# HCCD STAGE 1A

## SSD RESPONSE

## HCCD STAGE 1A

Image 2. Revised Stage 1A Ground Floor Plan, with circulation / re-programmable zones (shown dashed) wrapping around elements of the core (shaded red.)

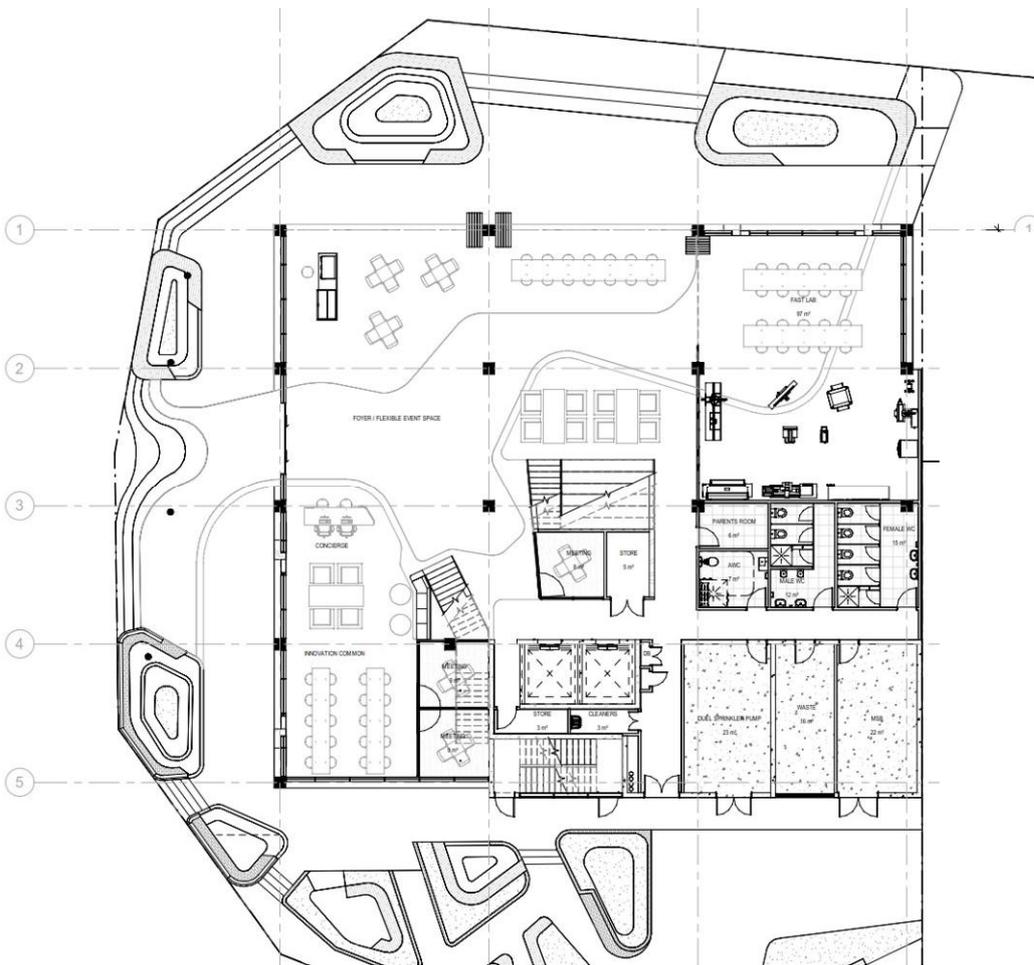
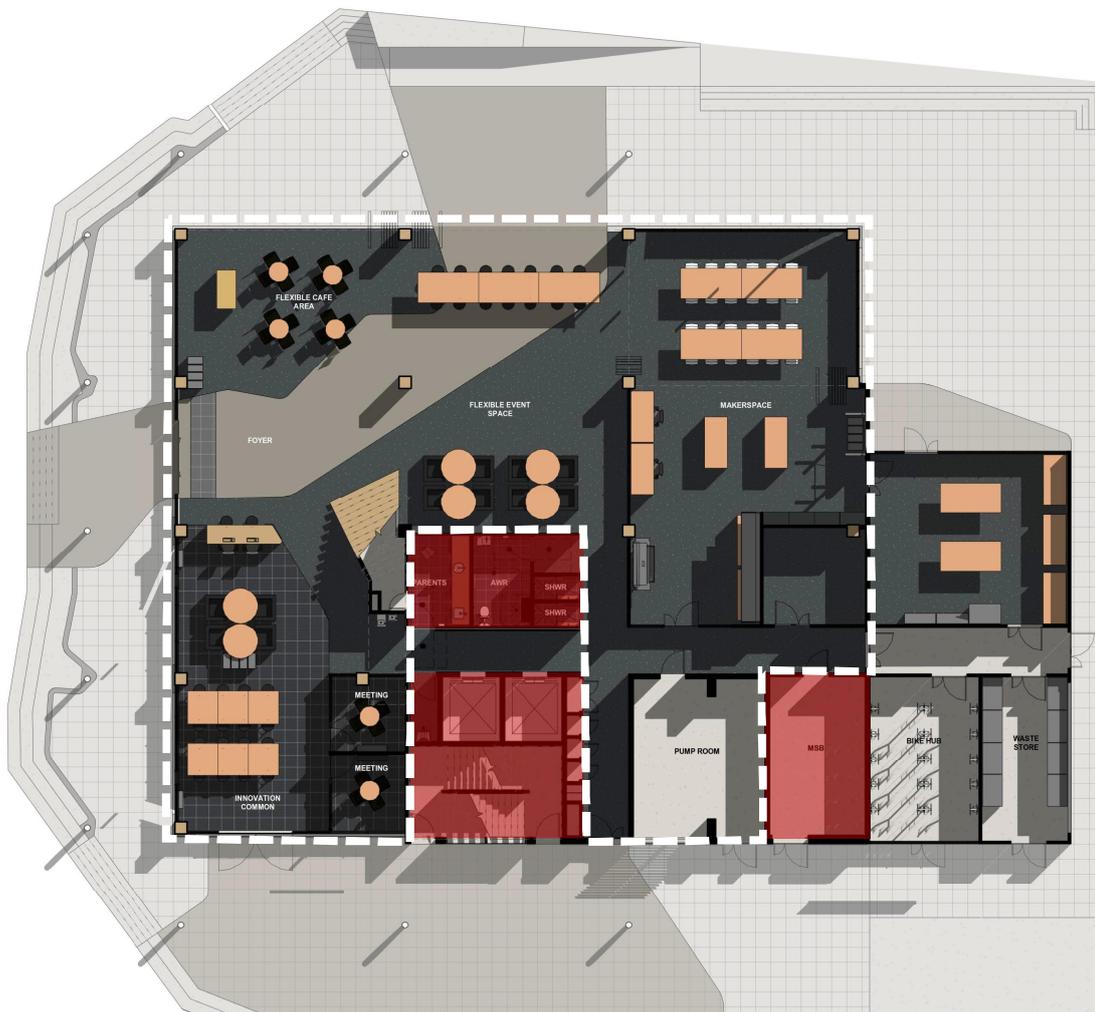
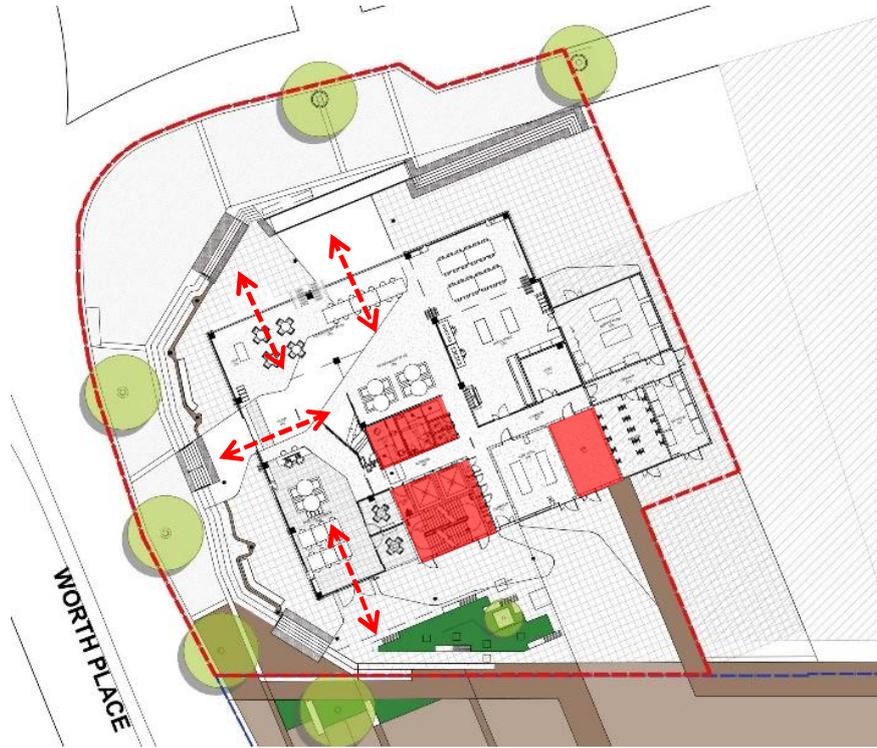
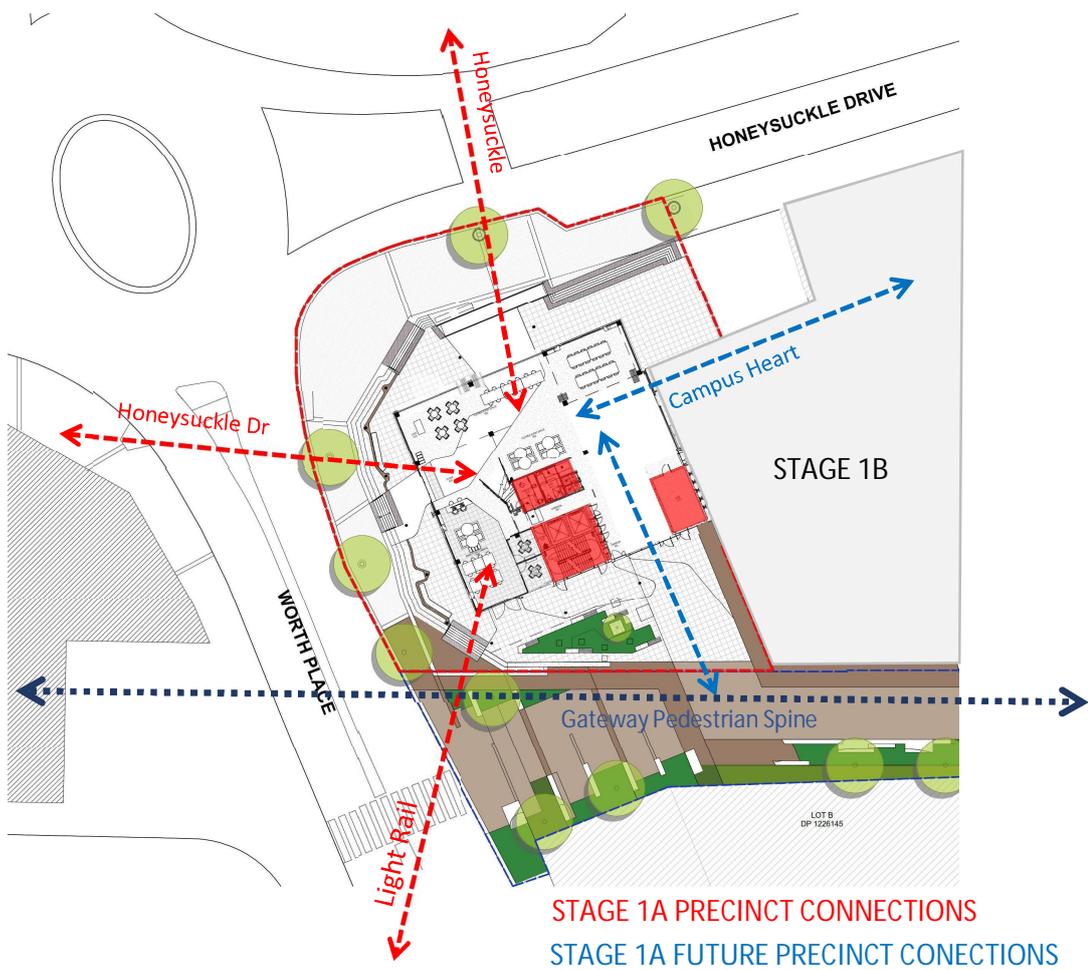
*While the panel understands that the evolution of the Black Box Theatre, a mock-up television studio, is no longer a suitable use for the ground floor, the visible presence and social impact of the ground floor still needs demonstration in some form. This is best demonstrated in the fast lab / maker space in the NE corner, which can spill out into the foyer, public space and potentially the square to the east – however this is located furthest from the gateways of the NW, SE and S.*

*Conversely if the Innovation Hub is a managed space (with a concierge) to protect the ideas being incubated and screen private conversations, then locating this on the south-east corner, the most visible and closest point to light rail and the city, exacerbates the tension between these needs and an accessible civic building welcoming to the public.*

*The position of the main entrance on the west, mid-block, and the 'back of house' south façade is problematic if this is the main approach from the light rail and city, and the university spine. The interstitial spaces, such as the corridor connecting 1A and 1B at ground, are narrow and functional, and do not facilitate the informal interaction that these spaces should typically afford in a university.*

The ground floor program has been shaped around a central vertical circulation core located on the central southern grid bay, providing for uninhibited future proofed emergency egress, and negating legacy issues for the adjacent Site 1B via rights of way or similar.

The residual ground floor space wraps around the core and affords all facades with physical access and exposure via doors and operable glazed walls. In addition, it provides for a flexible use of the space beyond the current brief, including future access points and the ability for the ground floor to address the future development of the HCCD including public domain and adjoining and adjacent buildings as it evolves.

Furthermore, the bike-hub, waste-store, and machine room have been envisioned as temporary structures, which effectively accommodate the program of Stage 1A throughout their life span, but can be incorporated into the adjacent Stage 1B upon development of the precinct. Similarly, the pump room is to be strategically re-located within the servicing of a combined 1A / 1B facility.

These future-proofing measures, combined with the strategic consolidation of ground floor amenities and vertical circulation mean Stage 1A will continue to demonstrate the themes of permeability and transparency within an evolving precinct. The resultant East-West circulation and Southern access opportunities are demonstrated within images 1 - 6.

Image 6. The location of the makerspace and machine room presents a visible display of activity to HoneySuckle Drive. The creation of a flexible adjacent outdoor square provides an outdoor extension of these activities, and can be expanded upon completion of the future Stage 1B.

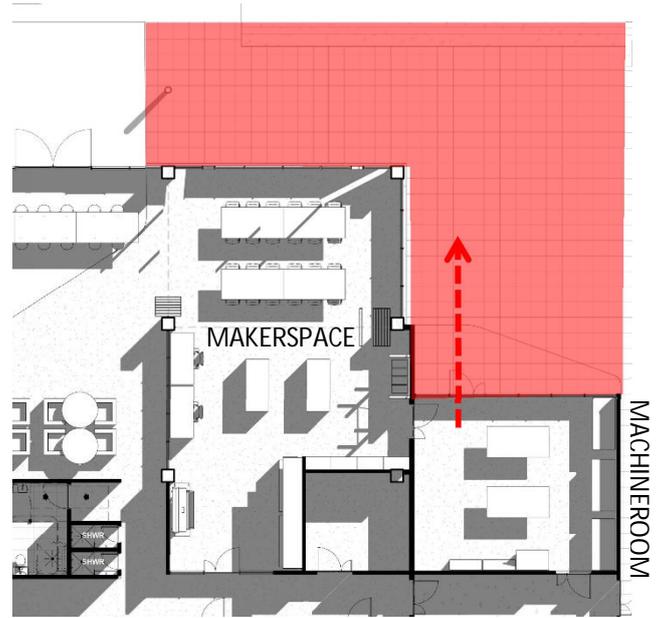
- *Retain and strengthen the building's relationship to the re-entrant square on the north-east corner of the site. As previously advised, strengthening and activating this square should be prioritised over the south-facing 'square'. To the extent that the south square has been retained, it needs further resolution. In the presentation, the 'sculpture garden' was noted to be away from the 'maker space' in the NE that fed it, and that this use may in fact shift to the NE square, further weakening the public domain on the SE.*

- *Develop the public domain plan for the site including adjacent spaces, in collaboration with a landscape architect, with links to the campus heart, spaces framed by built form, street addresses (and gateways / axes) all considered. The public domain should be resolved at least for land in UoN ownership, and would be improved by considering the framed spaces, streets and vistas around the site.*

The public domain has been developed by the UoN and considered in the redesign of the landscape as well as DDA pathways and access to the building. The awning has been reshaped to address multiple approaches to the building. In addition, the awning has been extended to now include the north, west and southern facades of the building and improve the amenity and use of adjacent external space.

As noted, the ground floor footprint and façade treatments have been developed to provide for agility in its program and adapt to the future development of the campus. The design of the façade provides for future access to the east, north, west and south providing for activation of adjacent public domain as it evolves including the campus heart via future connections through the adjoining site 1B.

Image 10. Articulation of stairs to define access into the building

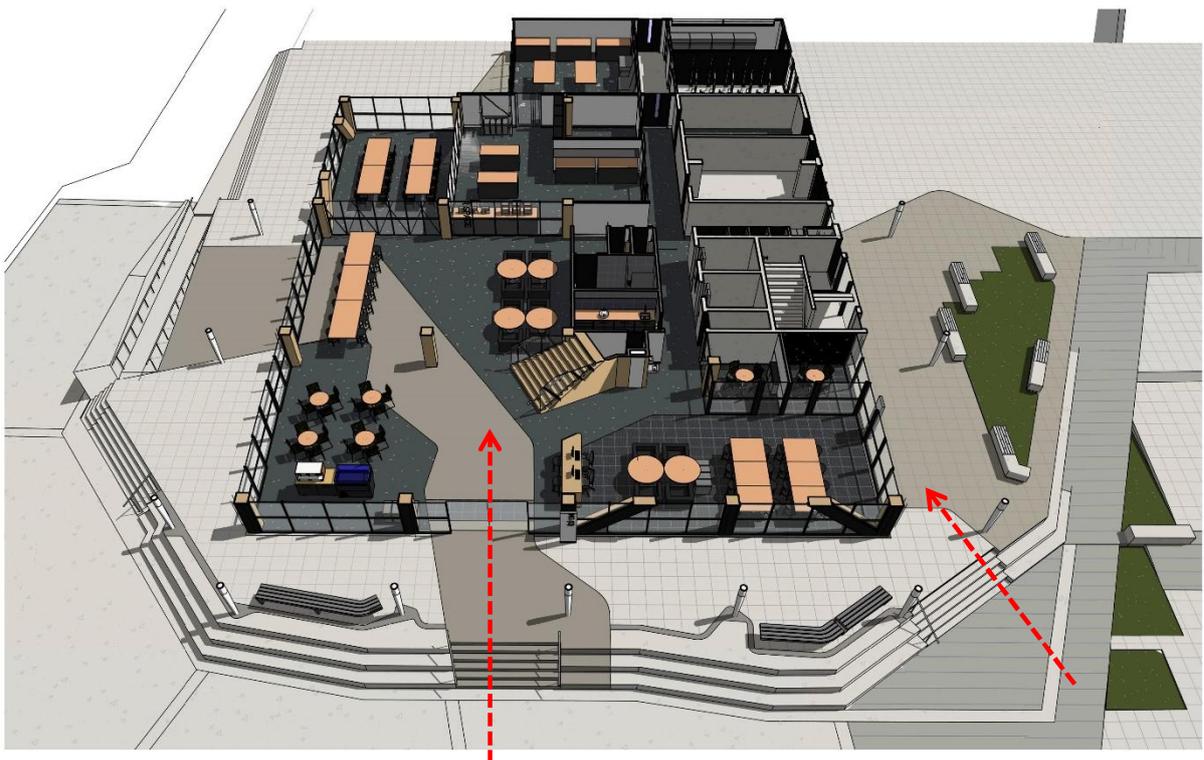
*Resolve the inclusivity of the ground plane from key approaches;*

- *Consider whether the building and its entrances could be better sited to be inviting and civic in presence rather than recessive.*

The primary western entrance is defined by its floor finish and the adjacent stairs that break the perimeter podium tiering as evidenced in Image 10. Similarly, the southern entry is defined by an adjacent stair set that break the perimeter podium tiering as evidenced in Image 10.

Image 12. Internal Foyer incorporating large steel beams supporting operable walls

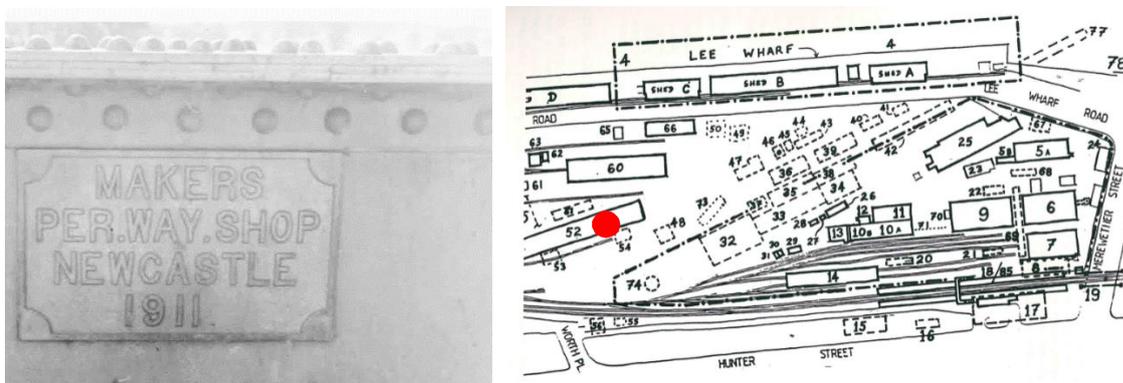
While the panel notes both engagement with UoN's Wollotuka Institute and use of an internal indigenous architect, the proposal has not advanced beyond the polished concrete floor with shell aggregate and ochre screed. The panel reiterates that this should be tested with the community.

The interpretation of the former shoreline in the ground floor surface treatment is commended, although on review after the meeting this appears to be in a different location to the shoreline presented in the concept master plan presentations. Please clarify what this line represents next time – is it the low water mark, or an interpretation of the ephemeral sand banks, or a graphic of a shoreline (not necessarily actual /mapped)? The panel notes the European heritage of the railway yards was not discussed – previously it was suggested this may return in another form (ie brick paving) – it would be good to clarify if any railway interpretation is proposed.

The use of polished concrete and shell aggregate has been tested within the local indigenous community via a presentation to the local elders. The line of the feature flooring is an abstract of the original shoreline to inform visitors that the original shoreline has changed and the land is filled and was originally part of the Hunter River. The site is located in the former mud flats (indicated by the red dot), which is represented in the colourisation of the concrete.

The European Heritage of the former Railway Workshops is represented in the use of exposed internal steel beams that support the external awning as well as internal operable walls. The beams are visible elements of the ground floor foyer and represent the fabrication of large steel members that occurred in the Per Way Bridge Shop (c.1895 – Building 32) which was the principal railway bridge builder for the Great Northern Railway.
